October 3, 2023

RE: Harbor Grove Project studies are inadequate

Sheet 9 - Grading Plan - revision 9-8-23

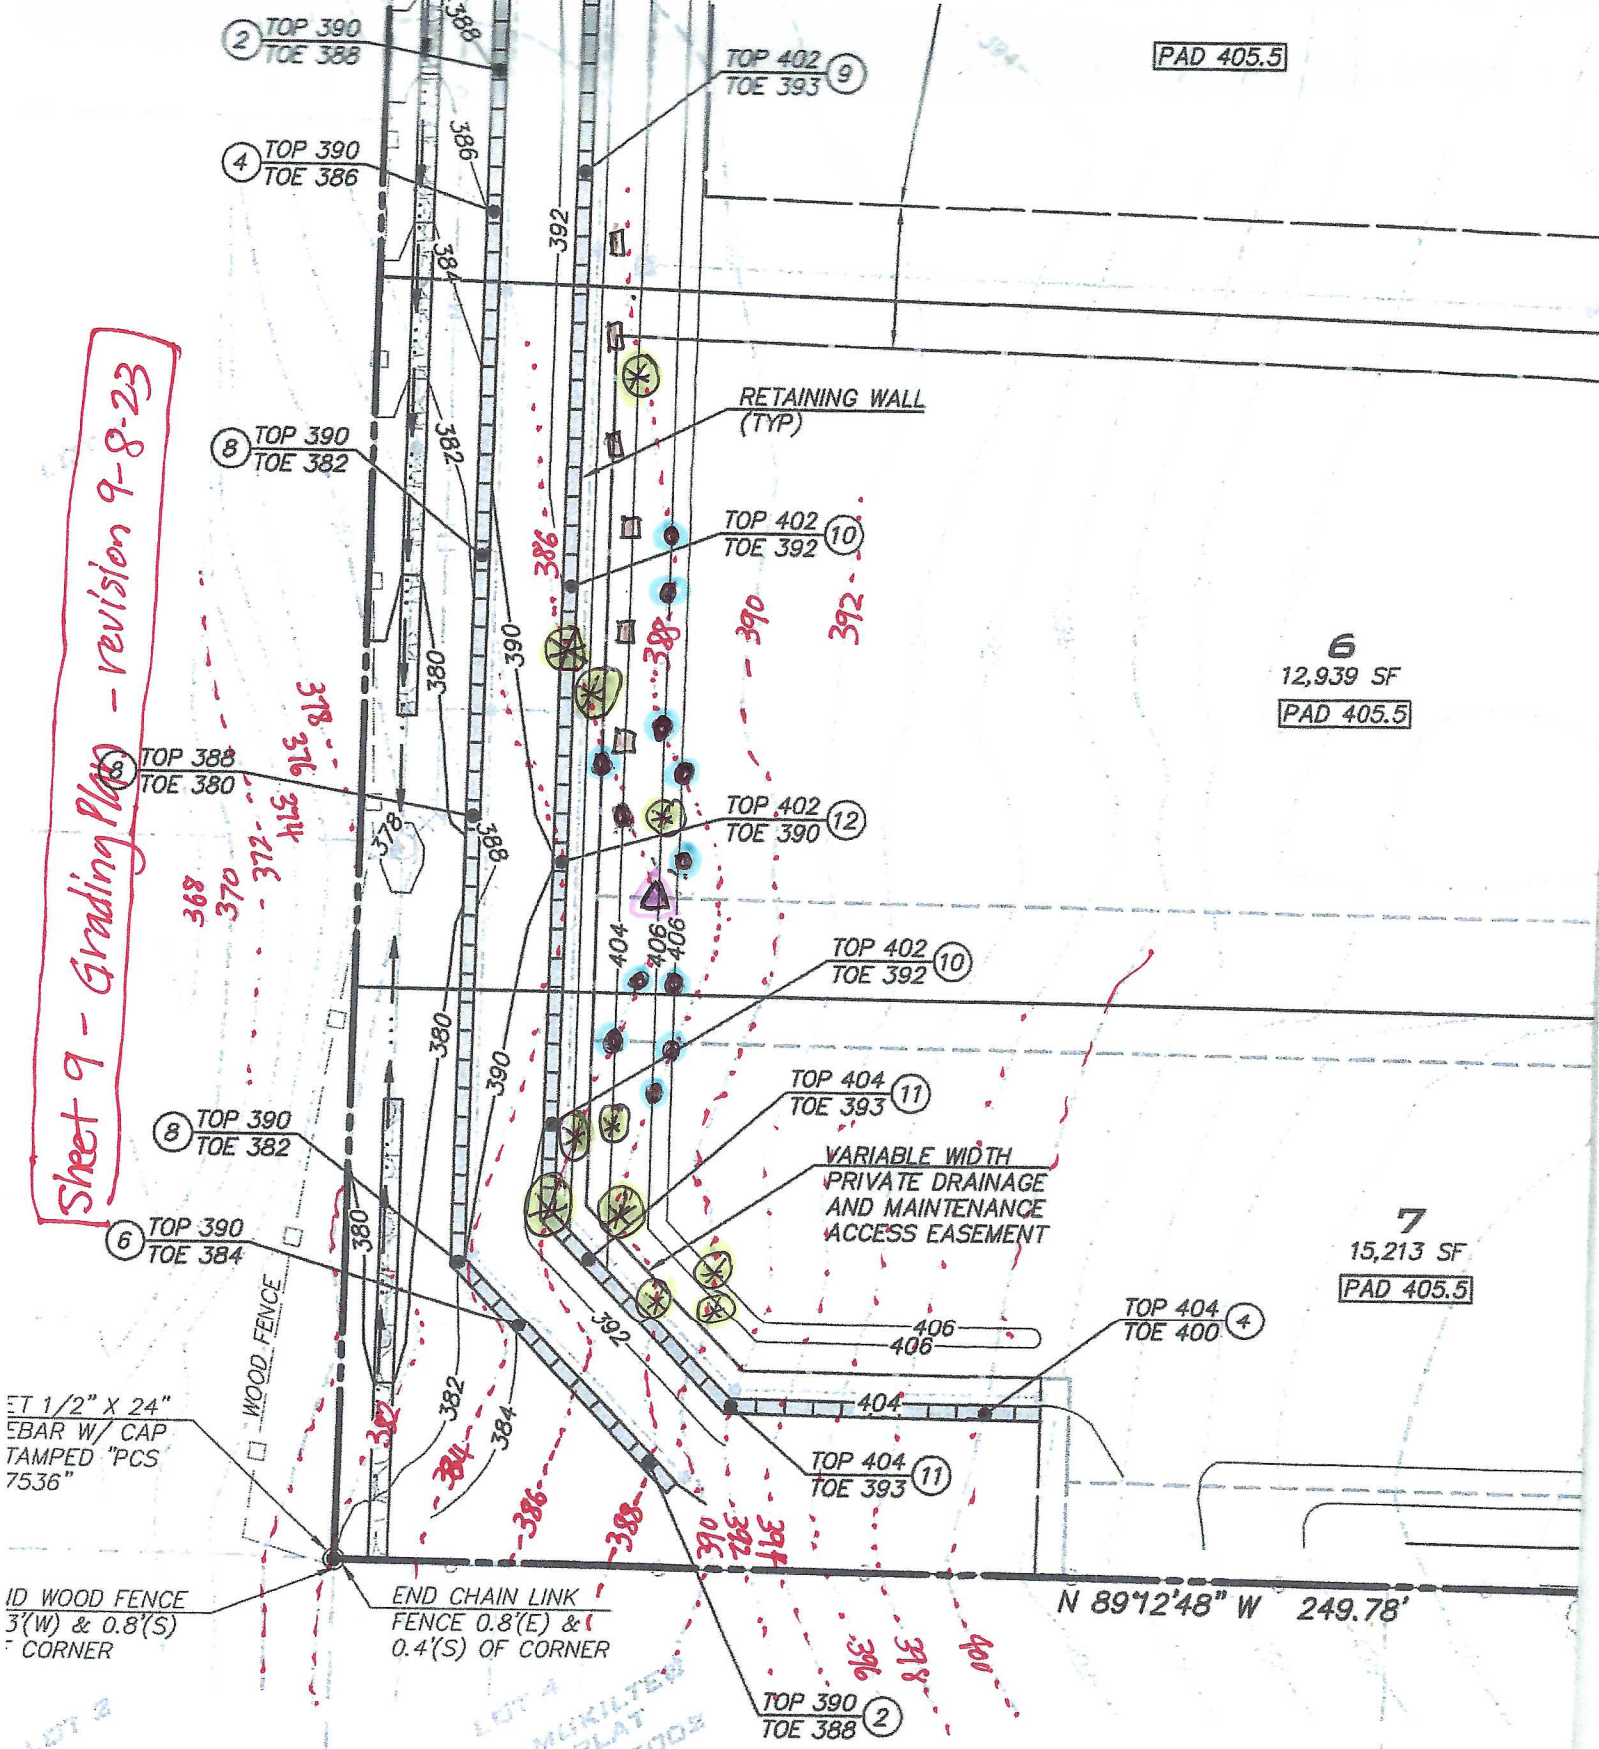
1. The 7-28-22 "Geotechnical Engineering Study" prepared by **Earth Solutions NW** (ESNW) for the Harbor Grove proposal is **incomplete** since it only evaluated the impact of a fill between 5 and 10 feet (see page 2 of this study). Based on the recent 9-8-23 Civil Plans, sheet 9 (Grading Plans), it identifies the elevation after filling and grading. In the SW corner of the project site (western part of Lots 6 and 7) the final elevation of the fill areas are greater than 10 feet. In some areas fill depth ranges from 15 to 20 feet.

For that reason, the applicant's geotechnical engineering study is incomplete, and the applicant needs to re-evaluate the stability of the fill areas (including the fill areas greater than 10 feet in depth).

Attached is a copy of the Civil Plans (revised 9-8-23), Grading Plans - Sheet 9, the western part of lots 6 and 7. I identified those areas where the fill is 15 to 20 feet deep.

- Areas where fill areas are > 10 feet
- $\Delta$  = 20' fill
  - $\bullet$  = 18' fill
  - $\otimes$  = 16' fill
  - $\square$  = 15' fill
